Product/Process Change Notice (PCN)

PCN #: PCN_IndGFH_20180429

Product Affected: WE-GFH size 3225 series

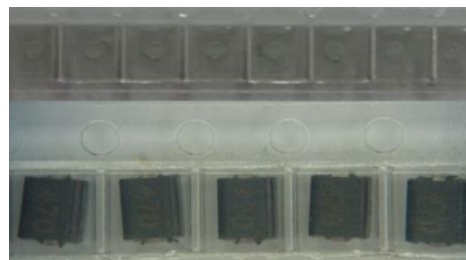
Implementing a new version of carrier tape will improve the process of adjusting Pick & Place parameters at the customer side. With improved adhesion technologies, the tape now has a better and stable removal process. Before we experienced deviations in the process of peeling force.

The visual difference between the new and current tape will be appreciable with the colour. Next picture shows the colour differences. At the right side we have the new one which is lightly darkened that the current one, at the left side.
